#### Attachment C

# REPORT OF PLANNING HEARING OFFICER ACTION Mr. Adam Stranieri, Planner III, Hearing Officer Bradley Wylam, Planner I, Assisting

# October 20, 2021

ITEM NO: 3	
	DISTRICT 7
SUBJECT:	
Application #:	PHO-1-21Z-57-06-7
Location:	Approximately 300 feet north of the northwest corner of 91st Avenue and Lower Buckeye Road
Existing Zoning:	S-1 (Approved C-2)
Acreage:	7.10
Request:	<ol> <li>Modification of Stipulation 1 regarding site plan, elevations, and conceptual landscape plan date stamped August 15, 2006.</li> <li>Deletion of Stipulation 1a regarding a master architecture theme.</li> <li>Deletion of Stipulation 2 regarding a pedestrian circulation plan.</li> <li>Deletion of Stipulation 3 regarding an enhanced landscape feature at the intersection of 91st Avenue and Lower Buckeye Road.</li> <li>Deletion of Stipulation 4 regarding an enhanced landscape feature on both sides of entrances on 91st Avenue and Lower Buckeye Road.</li> <li>Deletion of Stipulation 9 regarding a right of way triangle.</li> <li>Technical corrections to Stipulation 5, 7, 8 and 10.</li> </ol>

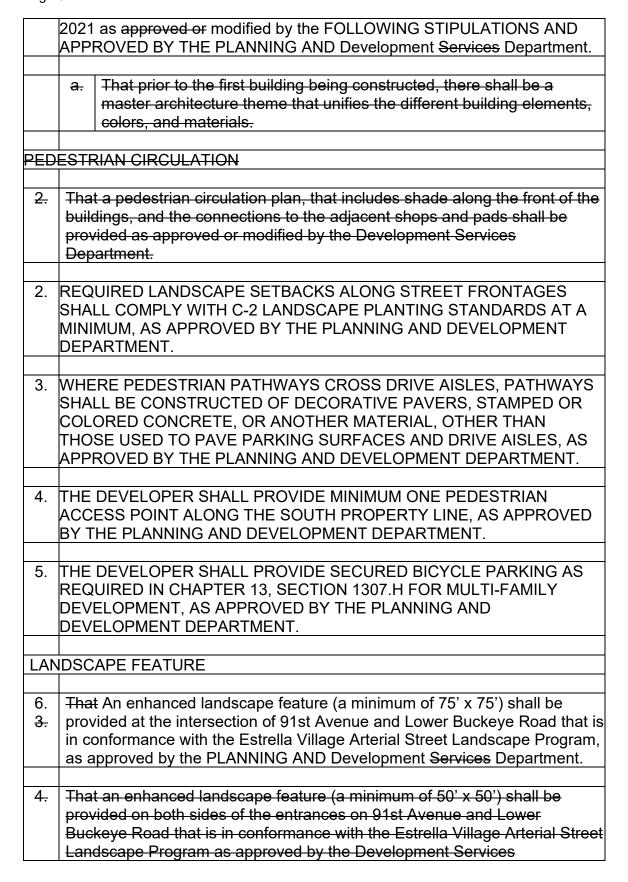
The subject property constitutes approximately 7.10 gross acres of the approximately 23.76 gross acres of the original rezoning area. The subject property is L-shaped with frontage on 91st Avenue and Lower Buckeye Road, while not including the hard corner, where a Circle K gas station is currently planned. The proposed plan depicts a multifamily townhome project consisting of 88 units at 14.21 dwelling units per gross acre. The townhomes are two-story and approximately 26-feet in height. The proposal will contribute to housing diversity in an area dominated by single-family detached units. The proposed conceptual elevations depict a variety of building colors, materials, and architectural features, including varied window sizes, steel awnings, metal balcony enclosures, and decorative garage doors.

The applicant's request is recommended to be approved with modifications to provide standard language regarding general conformance and remove reference to the conceptual landscape plan. The proposed conceptual landscape plan lacks plant species, spacing, and size information. Removing reference to this plan is intended to allow staff flexibility to enforce Existing Stipulations 5 and 6 which require compliance with the Estrella Village Arterial Street Landscaping Program and installation of a multi-use trail along Lower Buckeye Road.
